2025-0038 ITB
HVAC Controls Upgrade
Addendum 001 September 4, 2025

Attention Bidders: The following changes and additions are made to the bid documents. **Bidders are advised that the Revised Bid Form included with this Addendum must be used when submitting a bid. Any bid submitted on a previous version of the bid form will be considered non-responsive and will not be evaluated.**

Drawing Title MAH-1 Flow Diagram							
		1		AS-BUILT		5/14/02 MWK	
		REFERENCE DRAWING		no.		revision-location	
		sales engineer		project manager		application engineer	
Project Title WTA		drawn by		approved by		date	
		1/02/01		0		0	
		2000-026		drawing number		of 30	
		MAH1-1

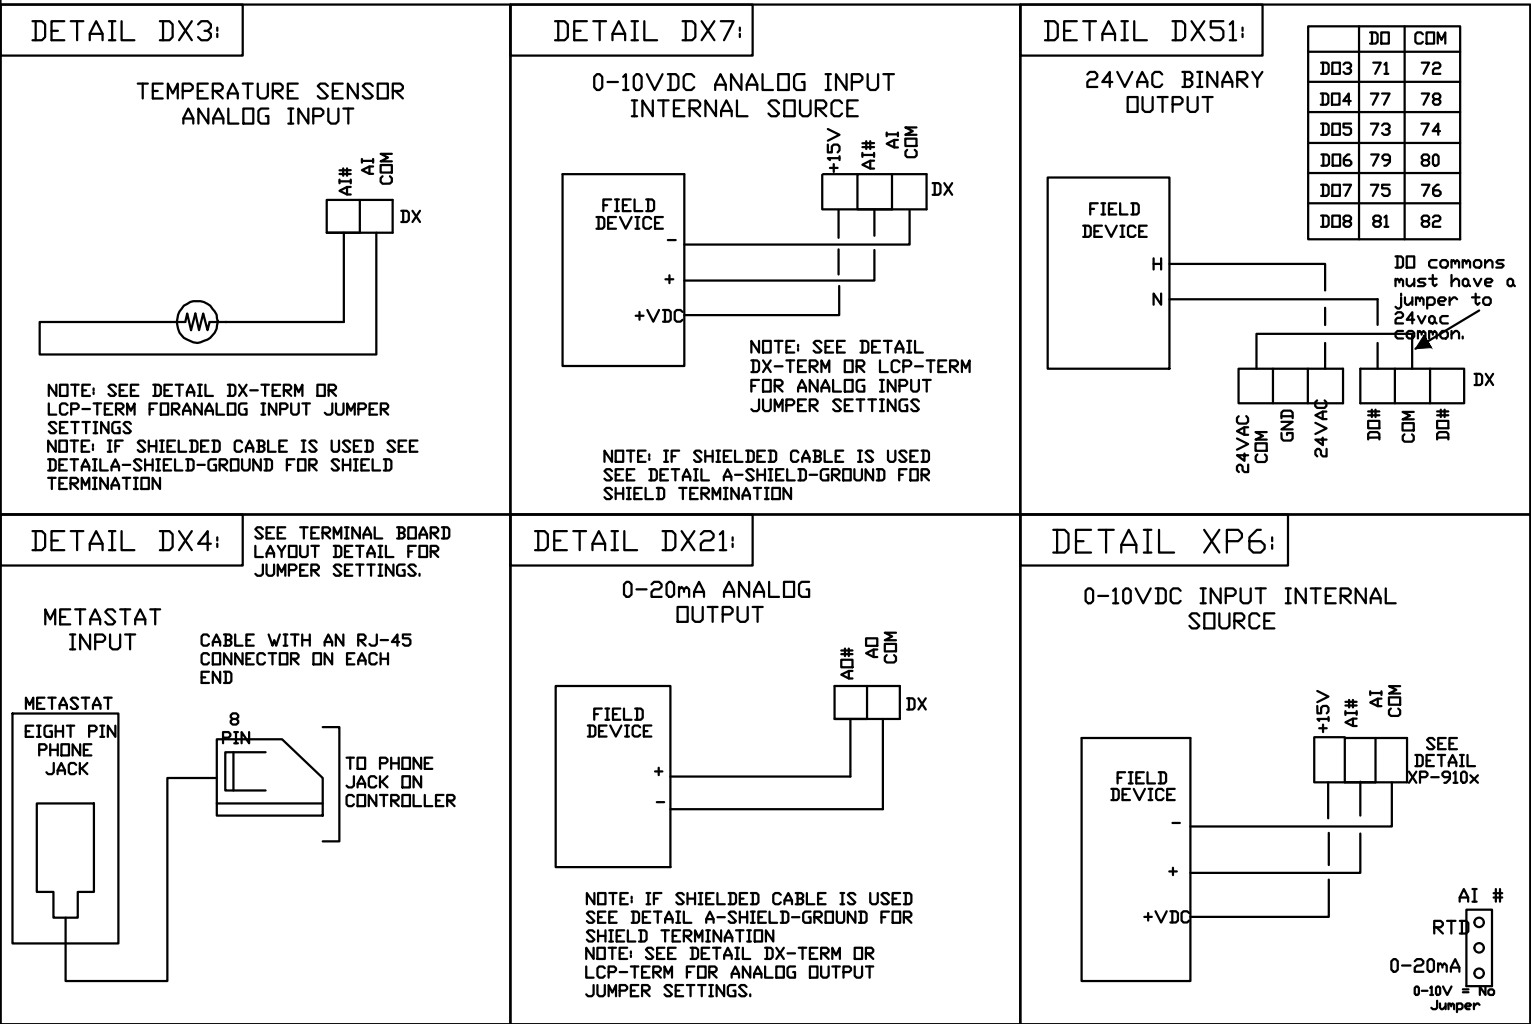
Answer 6	Location of building static pressure sensor is unknown. Contractor shall install a new one as part of this project.
Question 7	Which HVAC unit currently does not have a VFD installed on the exhaust fan, and needs one installed as specified in the ITB? And can a photo of the nameplate for the unit be sent out to potential bidders?

Question 13	What are the benefits of VFD on MAH-1 and should this be an alternative bid item?
Answer 13	Installing a VFD (Variable Frequency Drive) on the exhaust fan of MAH1 would help to balance the air pressure in the shop more effectively. This would require additional pressure sensors that are not currently installed. See Answer #7 stating this will be bid as alternate no. 001. Use updated bid sheet. Update drawings showing alternate 001 will be provided in the forthcoming Addendum 002.

Answer 7	MAH-1 currently does not have a VFD. VFD installation and supporting duct static pressure sensor for MAH-1 is to be bid as Alternate 001. A revised bid sheet is attached which must be used when submitting a bid. Any bid submitted on a previous version of the bid form will be considered non-responsive and will not be evaluated. The requested photos are attached to this Addendum. Update drawings showing alternate 001 will be provided in the forthcoming Addendum 002.
